3.10 VISUAL RESOURCES COMMENTS AND RESPONSES

Figure 3.10-1: Long Path Trail Key Map
 Minisceongo Park

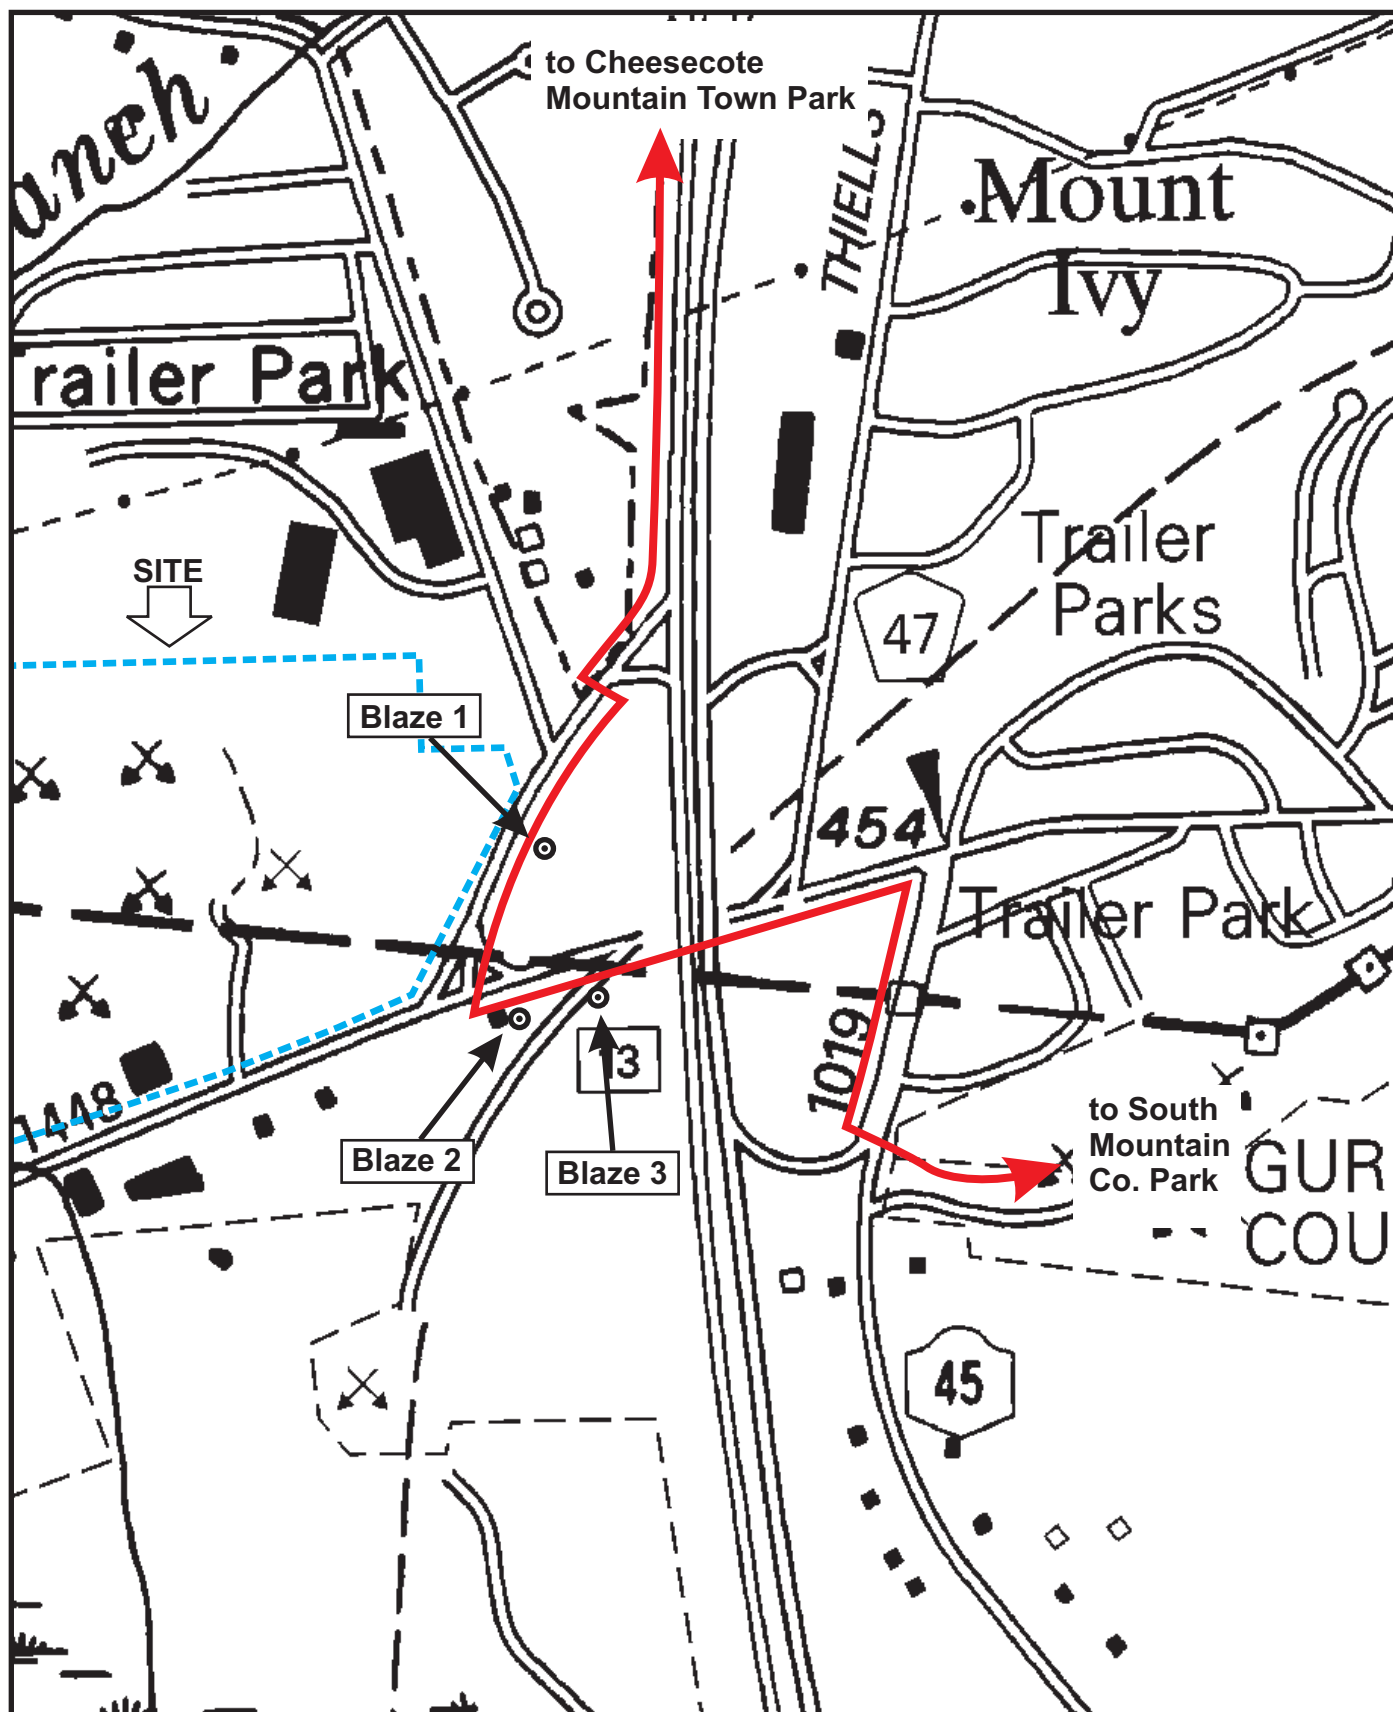
Comment 3.10-7 (Letter #4 Frederick P. Clark Associates, Inc., March 13, 2009): The long path should be shown definitively on the map. The text description is not sufficient to judge the impacts to the Long Path views.

Response 3.10-7: *Figure 3.10-1 illustrates the location of the Long Path within the project vicinity and Figure 3.10-2 provides photos of the trail blazes within the project vicinity for field verification. The first photo shows a trail blaze that is located on the east side of the Route 202 on/off ramp adjoining the project site to the east. The second blaze is found on a utility pole in front of the Mt. Ivy Diner. Lastly, the third photo illustrates a blaze on the south side of Route 202 approaching its intersection with Route 45. This should assist in providing the commentator with the specific location of the trail in the project vicinity.*
